VILLAGE BOARD AGENDA

- b. First Amendment of Development Agreement- Footworks Dance Company
 - c. Change Request #6 to SMA Construction Services in the amount of \$-10,458.00 for the Kimberly Street & Parks Dept. Building

- d. Change Request #7 to SMA Construction Services in the amount of \$9,954.32 for the Kimberly Street & Parks Dept. Building
 - e. Application for Temporary Class "B" Beer license- Kimberly Baseball Organization for Sunset Classic Tournament June 20-22, 2025 (Danielle Eckes, Agent)

Kimberly Street and Parks Department - RFI P-8

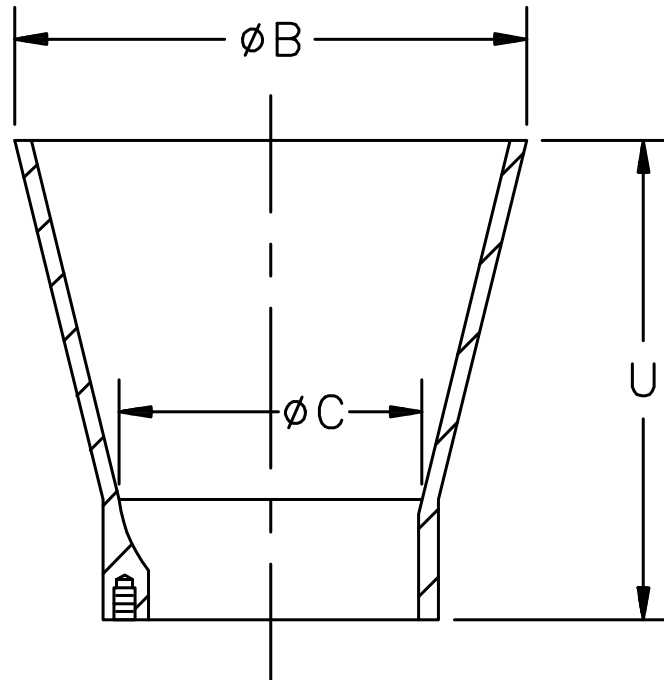
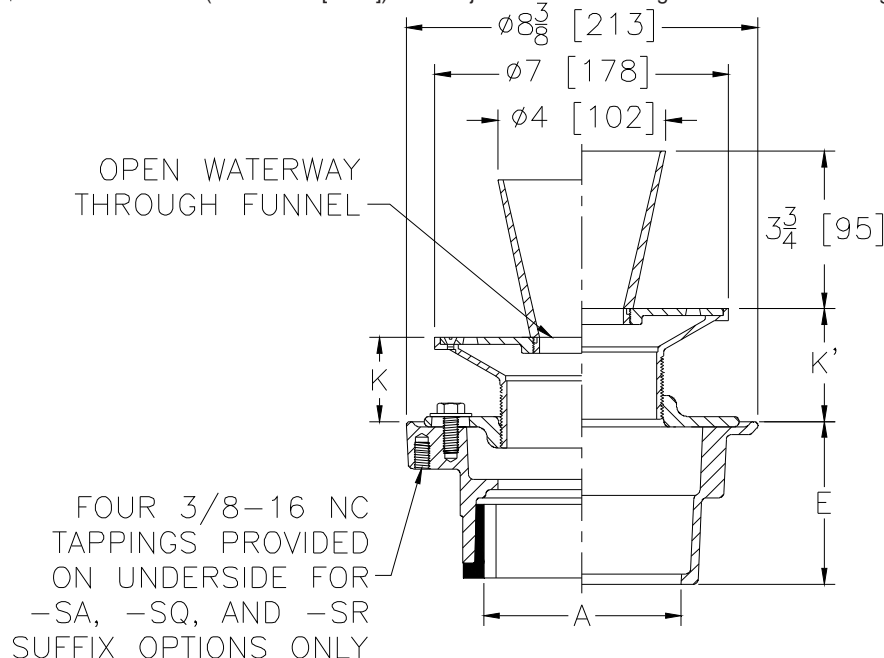
Project details: *Furnish and install Mezzanine Floor Drains and Hub Drains per RFI P-8*

Drawing P204 shows (5) SD-1's at MEZZ 1 and 2.

Is the intent to provide a hub drain (HD-1) at these (5) locations or (5) SD-2's (Floor Drain w/ Z328 receptor)? Shop drawing attached.

Response ilo current drawing Drain Schedule. Please see attached breakouts and RFI.

RFI P-10 FCO-3

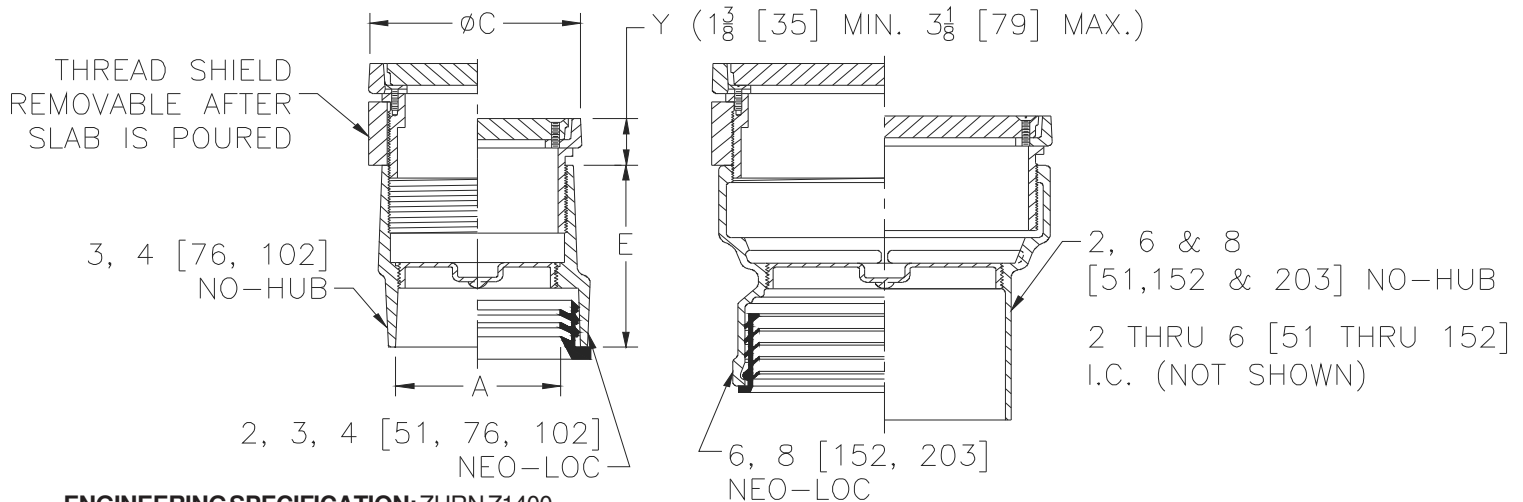
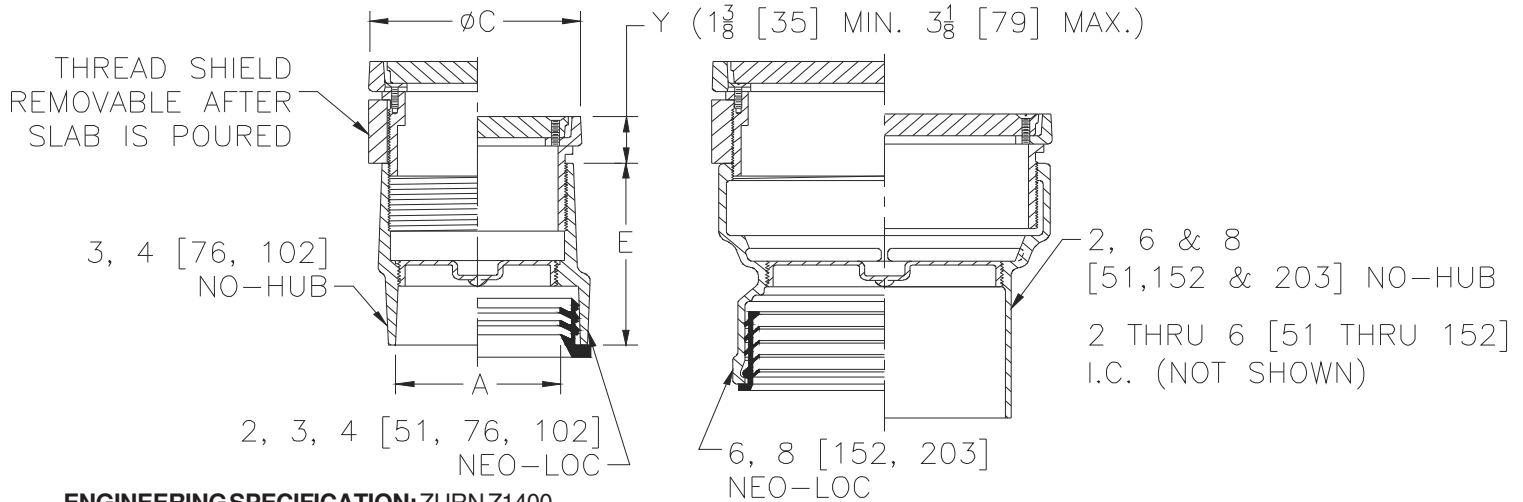
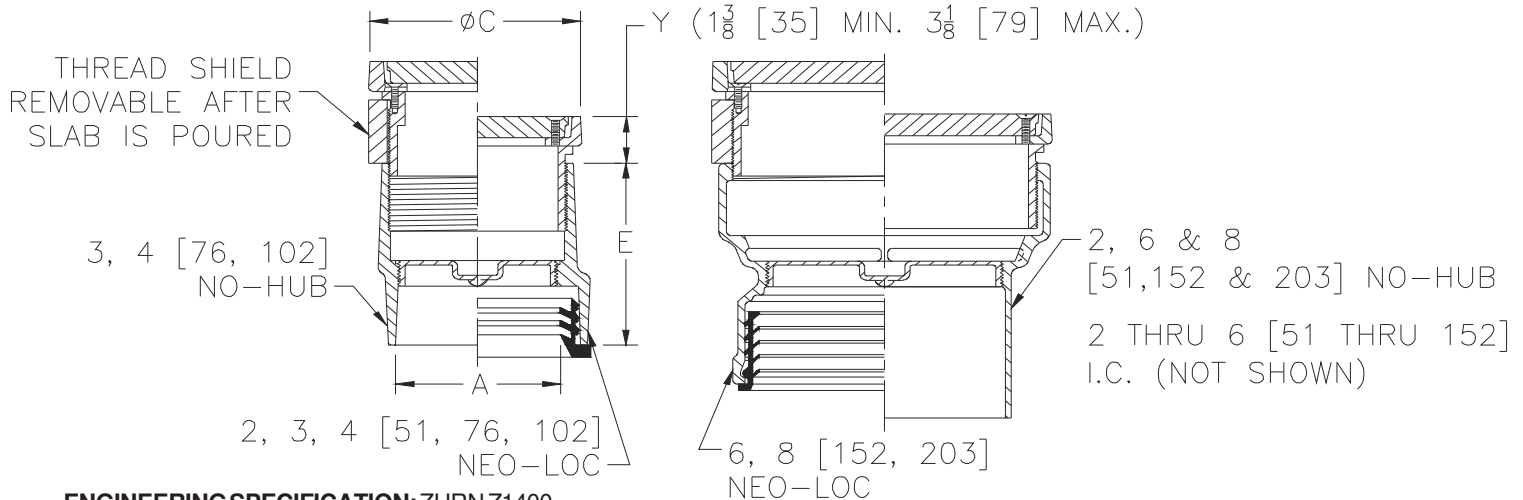
Project details: *Per RFI P-10. RFI and Submittal response requires Veneer Tops ilo Cast Iron tops at P600 Drain Schedule. Please see attached breakouts and responses.*

The FCO-HD was changed from Cast Iron top to Veneer Nickel per attached submittal responses. This change added \$1,233.00 to my costs. All FCO's are currently onsite per 11-21-2045 review.

- 28. RD-1 – Reviewed.
- 29. OD-1 – Reviewed.
- 30. DSN-1 – Reviewed.
- 31. CB-1 – **Revise and Resubmit** – Not Submitted.
- 32. ECO – Reviewed.
- 33. FCO-S – Reviewed.
- 34. FCO-C – Reviewed.
- 35. FCO-HD – Provide Extra-Heavy-Duty Veneer Top.
- 36. VCO – Reviewed.
- 37. WCO – Reviewed.
- 38. MH-1 – **Revise and Resubmit** – Not Submitted.

P103

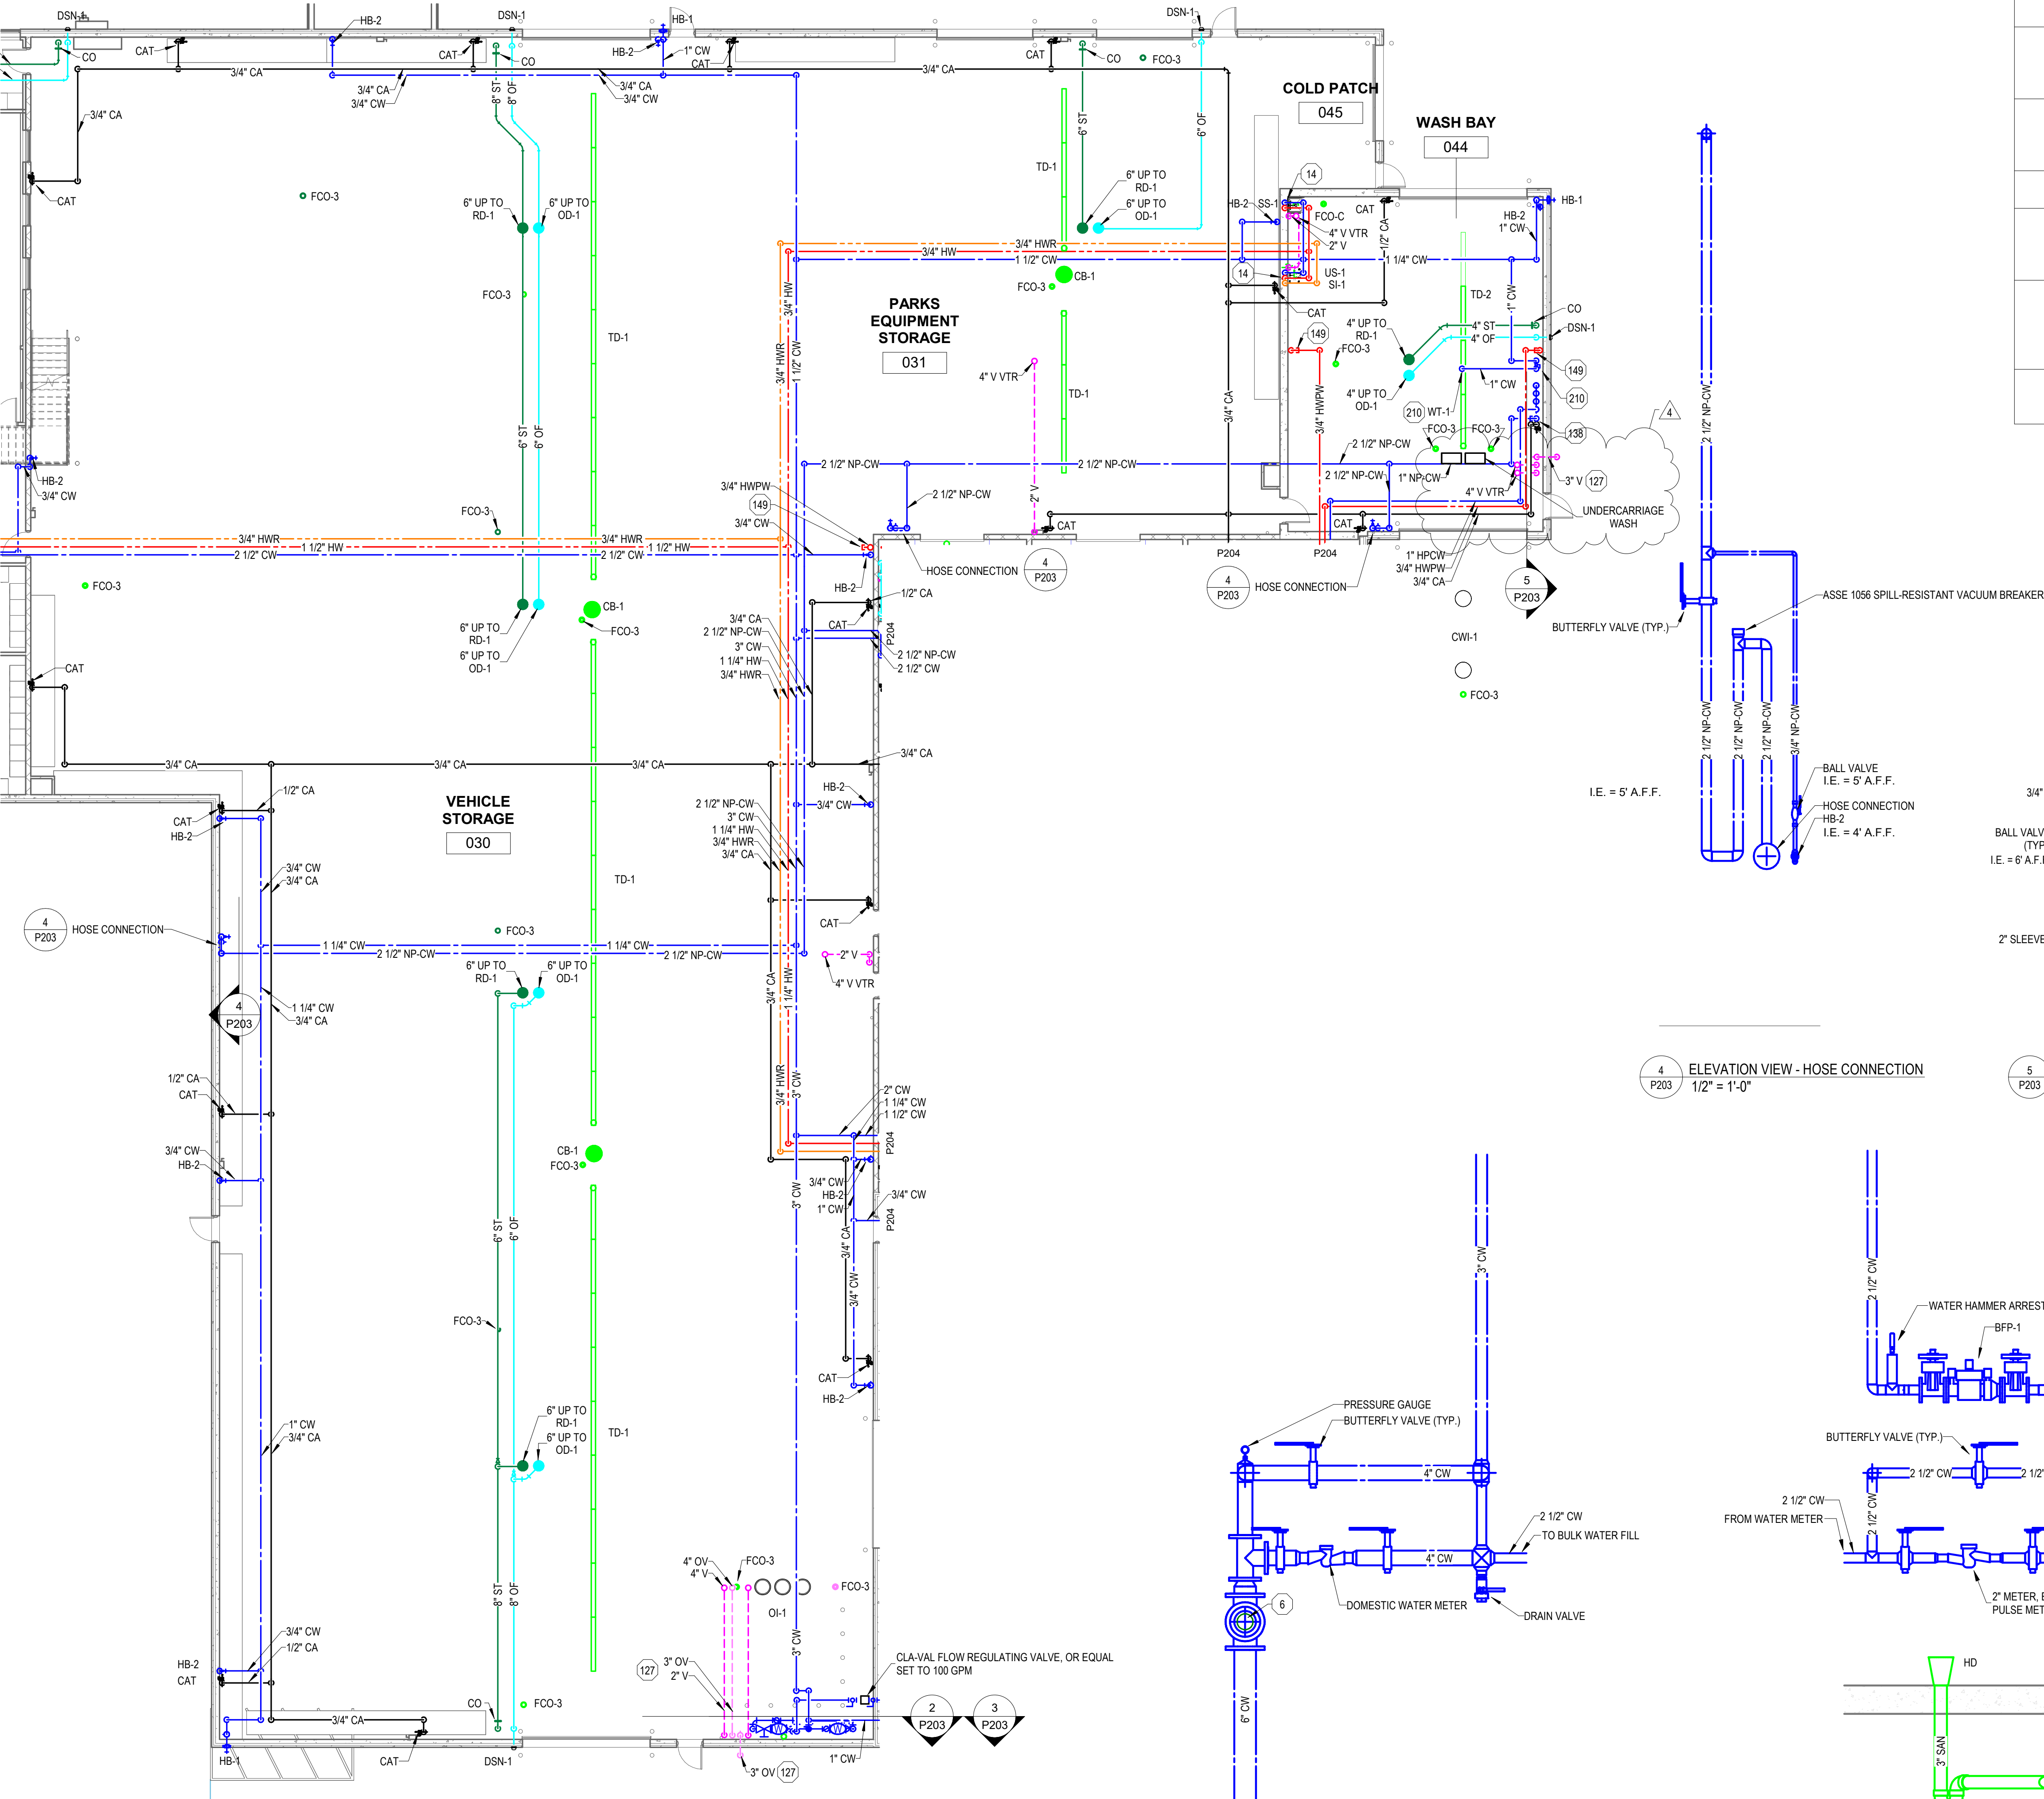
- With revised location of undercarriage wash boxes at 9'-2" from inside of OH door it puts the scheduled TD in conflict. A narrower drain would be a very tight fit and would likely result in re stocking fees of new 4" drain. Discussion led to an agreement to shorten existing TD to avoid conflict with boxes.
- See attached plan sheets depicting UG plumbing vs. what equipment manufacturer has listed on documents supplied to us. Looking to verify changes in contract drawings for equipment installation - See EGI Attachment for further reference.

Drawings show 6" underground piping from CWI-1 to Undercarriage Wash Equipment.

6" cleanout access is required at change of pipe size to the 2" drain connections at UC Wash Equipment therefore we need to install 6" x 2" reducing wyes and add 6" floor cleanout at end of each branch. If the 4" referenced at Note #128 applies we should install 4"x 2" at connections and 4" floor cleanouts. This would be more economical.

This also applies to the 4" trench drain connection - drawings show 6" drain to 4" throat trench drain.

As part of this RFI we are requesting a revised wash bay plan to show necessary changes to be used for construction.
